9/6/19 (1)
LAKEFRONT
TYPICAL FLOOR DOOR DETAILS.

TYPE	D1A (SINGLE LEAF WOODEN FLUSH DOOR) TYPICAL FLOOR	TYPE	D2A (SINGLE LEAF WOODEN FLUSH DOOR)
STRUCTURAL SIZE OPENING	1050 X 2250 ~~X~~ 1100 X 2250	STRUCTURAL SIZE OPENING	900 X 2250
LOCATION	MAIN ENTRY	LOCATION	BEDROOM
FRAME TYPE	RED MIRANTI FRAME OF SIZE 144 X 58 FINISHED ~~IN MELAMINE POLISH~~ IN 3 COATS OF POLISH.	FRAME TYPE	RED MIRANTI FRAME OF SIZE 94 X 58 FINISHED ~~IN MELAMINE POLISH~~ 3 COATS OF POLISH.
SHUTTER TYPE	~~40-45~~ 38MM THICK SOLID CORE FLUSH DOOR, FINISHED WITH 1MM THK LAMINATE ON BOTH SIDES	SHUTTER TYPE ✓	32MM THICK SOLID CORE FLUSH DOOR, FINISHED WITH 1MM THK LAMINATE ON BOTH SIDES

D1A
SINGLE LEAF WOODEN FLUSH DOOR

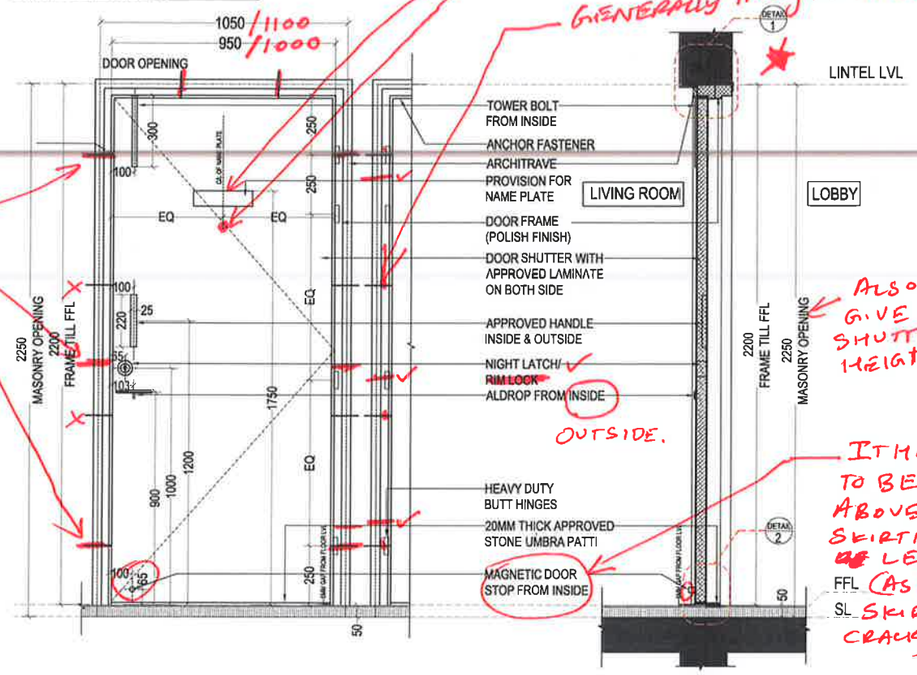
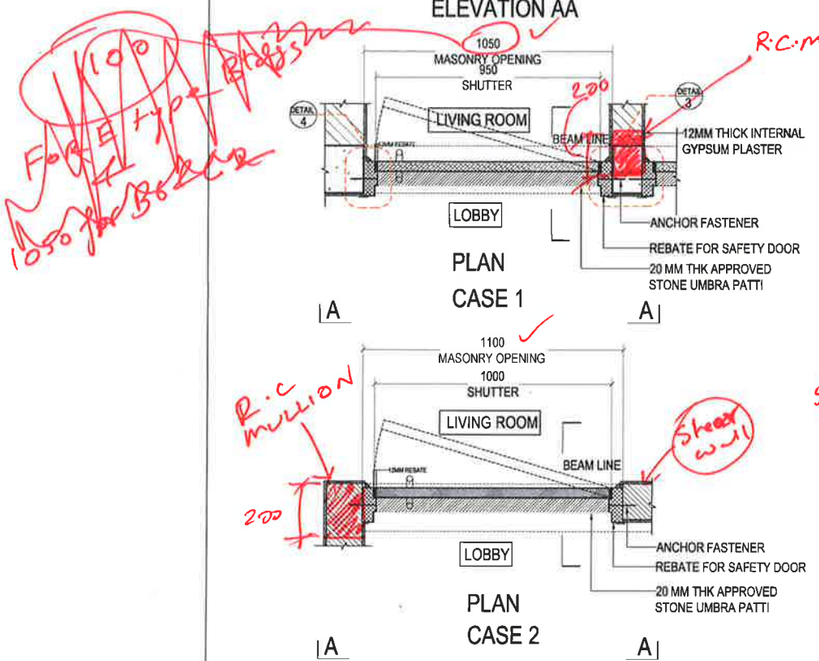
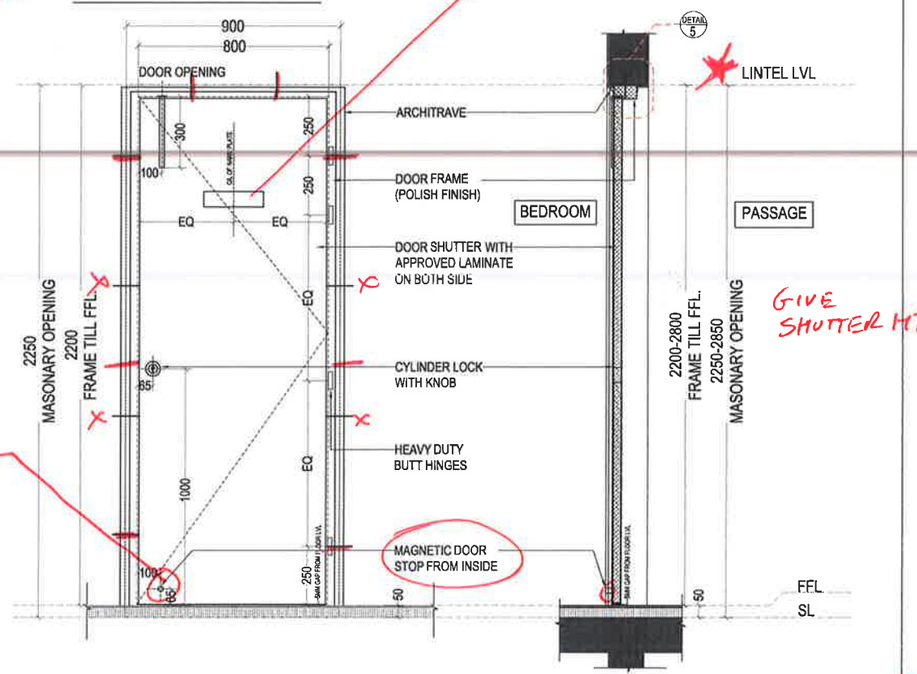
FOR TYPICAL FLOOR IT SHOULD BE D1.

NAME PLATE TO BE AS PER ATTACHED FILE
EYE VIEWER REQUIRED.
GENERALLY THEY GO STAGGERED.
ANCHOR FASTENERS TO BE 3 NOS. ON EACH SIDE & 2 ABOVE
ALSO GIVE SHUTTER HEIGHT.
OUTSIDE.
IT HAS TO BE ABOVE THE SKIRTING LEVEL (AS THE SKIRTING CRACKS)

R.C. MULLION
1. CHANGE THE DETAIL AS PROPOSED (RECESSED)
2. DOES IT APPLY FOR 2.5 BHK DOOR ALSO ??
3. THE PLAN CONDITION TO MATCH WITH ACTUAL AS PER CIVIL DWG ISSUED.
4. 10 mm FOAM MISSING BETWEEN WALL & FRAME 3 SIDES.

D2A
SINGLE LEAF WOODEN FLUSH DOOR

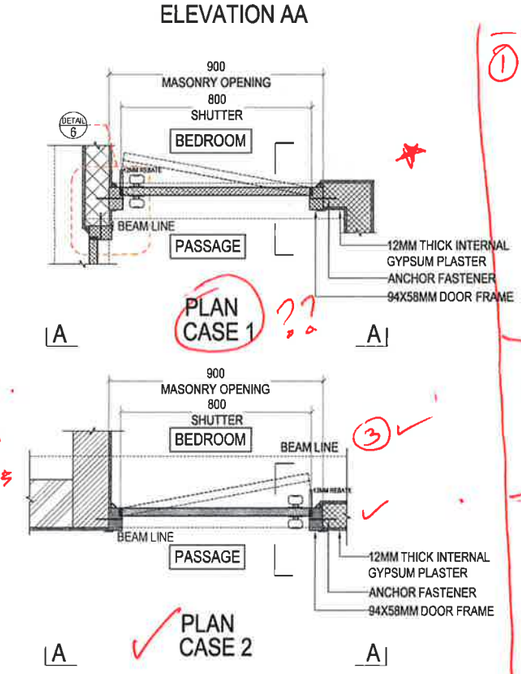
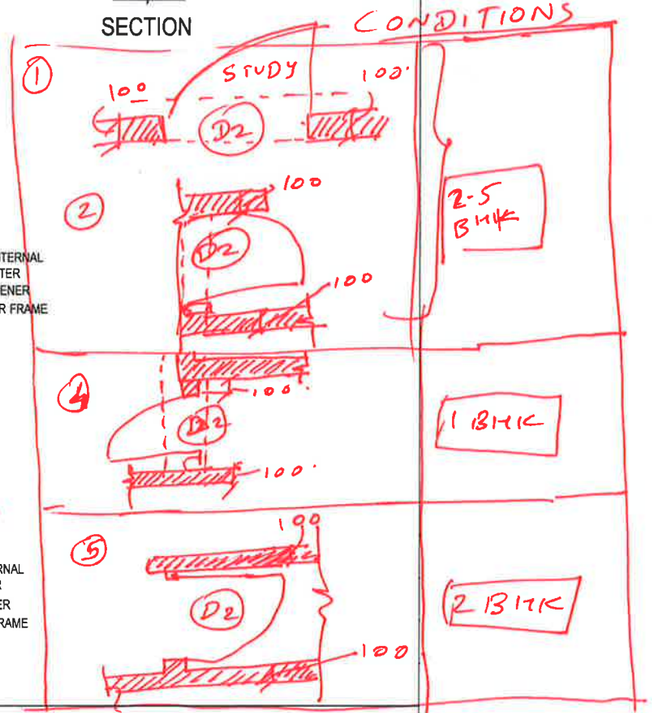
NAME PLATE REMOVE.
GIVE SHUTTER HT.

D4A

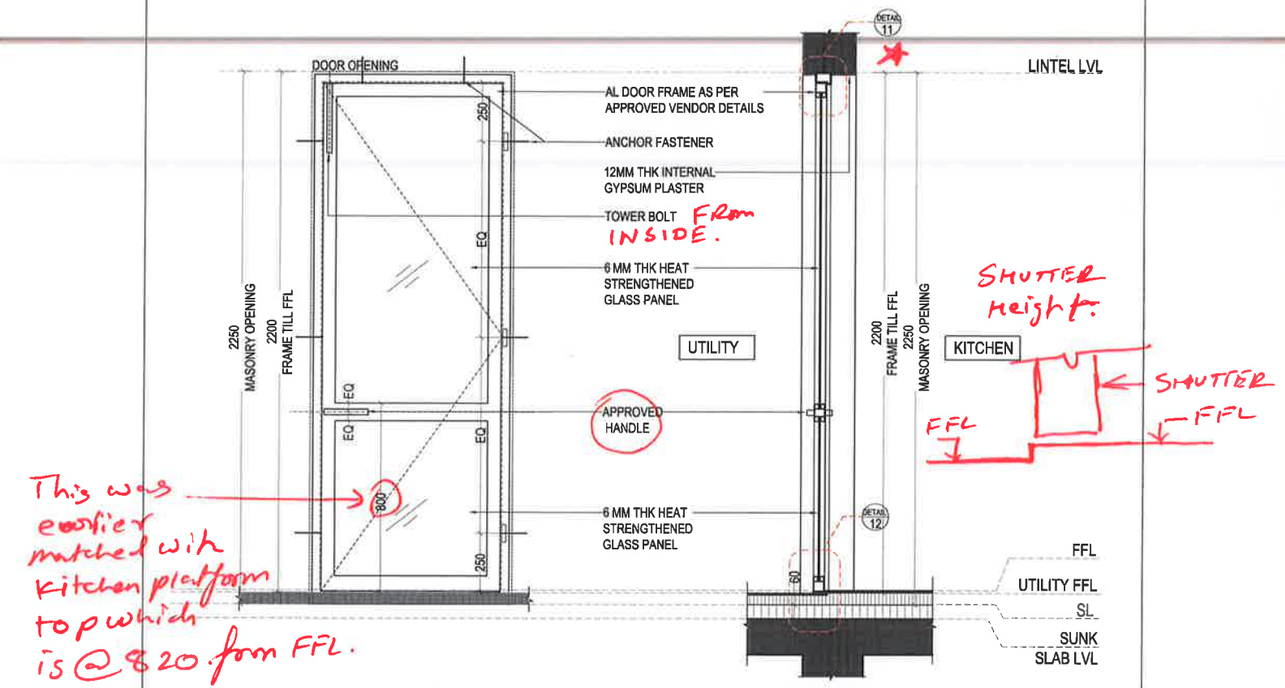
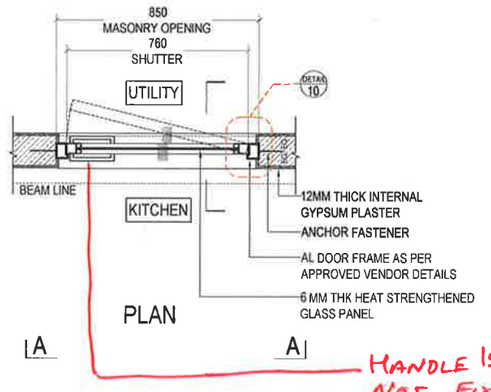
This was earlier matched with kitchen platform top which is @ 820 from FFL.

* 10 mm Foam is missing

HANDLE IS LEVER TYPE. NOT FIXED.

D6A

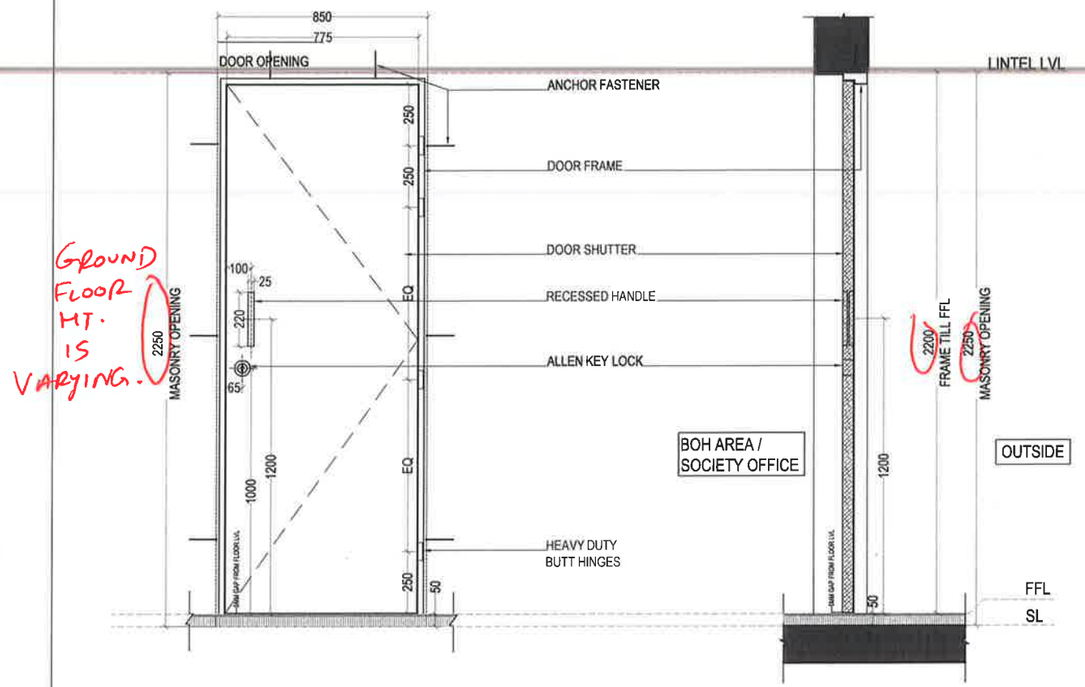
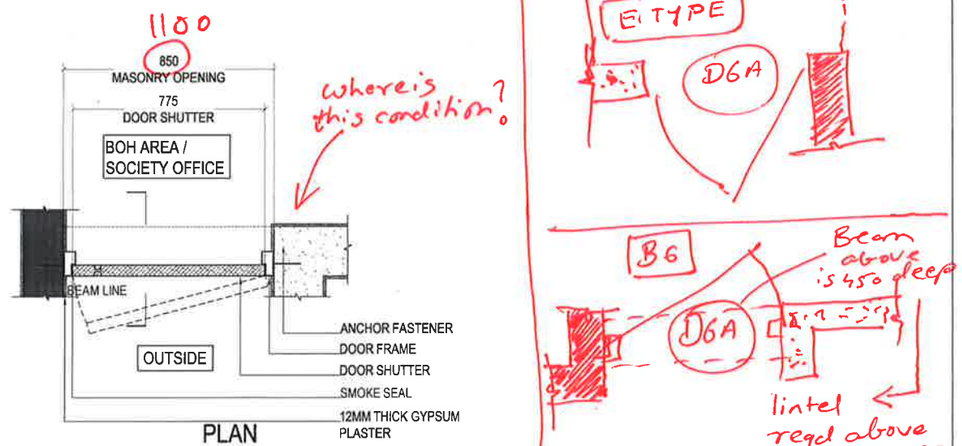
FD1A → HTS. WILL BE DIFF. FOR ST.1 & ST2 IN A SAME WING BASED ON NO. OF INITIAL RISERS IN 'E' TYPE.

GROUND FLOOR HT. IS VARYING.

FD1A D5A — ?

SINGLE LEAF FIRE RATED DOOR

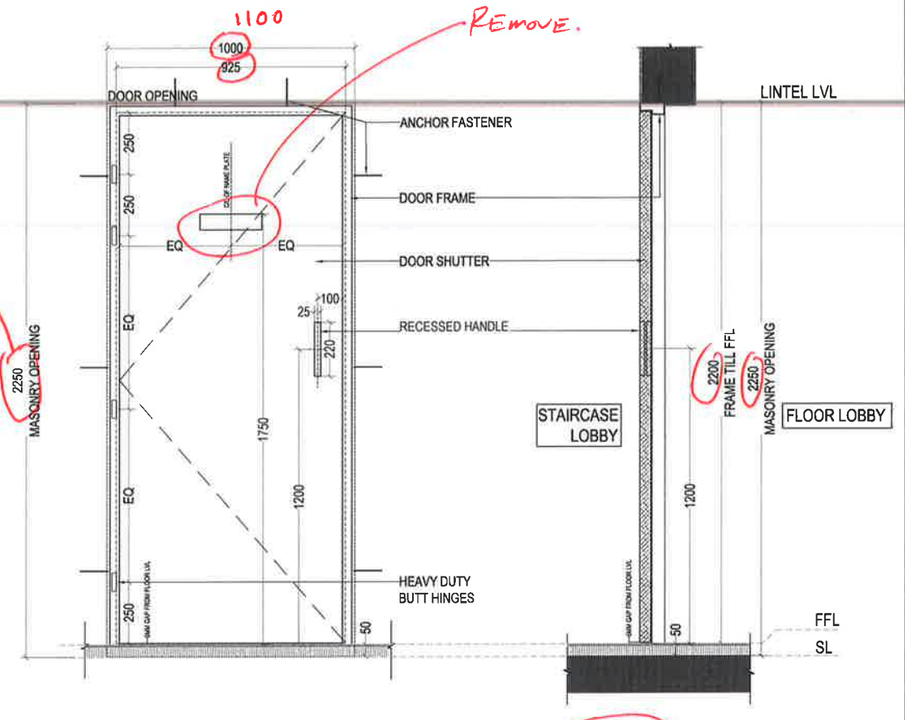
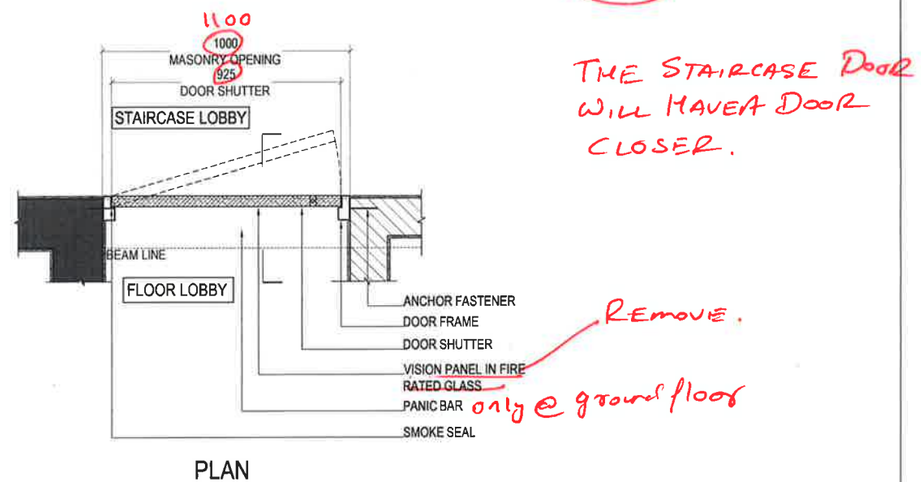
THE STAIRCASE DOOR WILL HAVE A DOOR CLOSER.

REMOVE.

only @ ground floor

RAL SHADE?? golo??.

DD1A DD2A

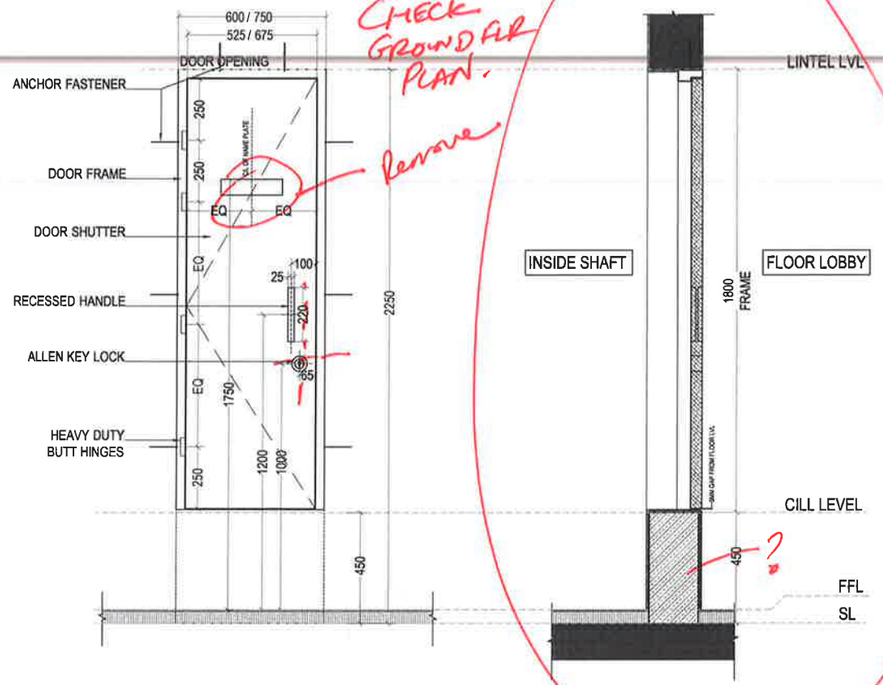
Its a double leaf door.

THIS DOOR NOMENCLATURE IS SAME FOR FHC DOOR ALSO. CHECK GROUND FLR PLAN.

FHC DOOR WILL HAVE GLASS PANEL

PLEASE USE CORRECT SECTIONS. Typical

CHECK DOOR OPENINGS IN E TYPOLOGY & B6 Separately.

IS THIS FOR GROUND OR FOR TYPICAL FLOOR ??

Give Conditions for B6 4E, 12 B6 Both

D7A D10A

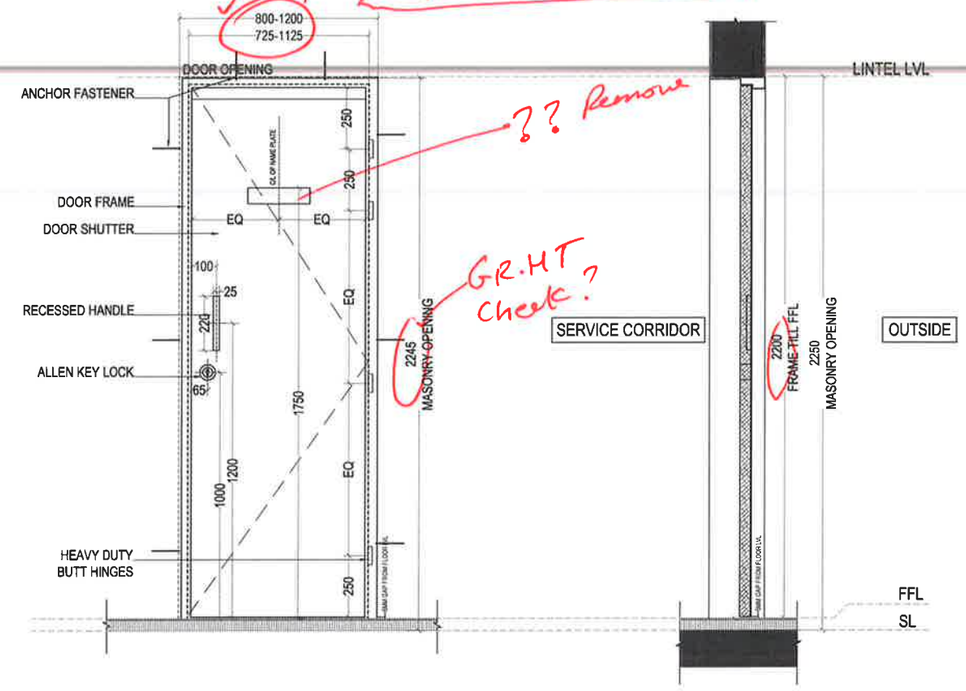
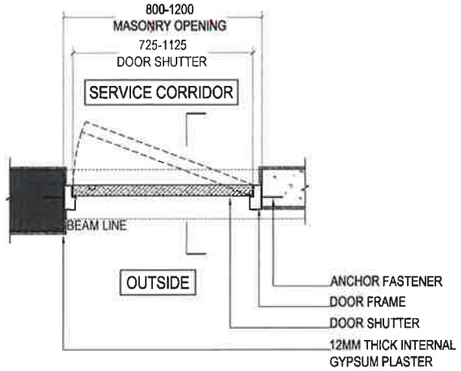
Why a fire Rated Door Required for a GUARDIAN STORE ???

CHECK IF D10A is required as per MEP.
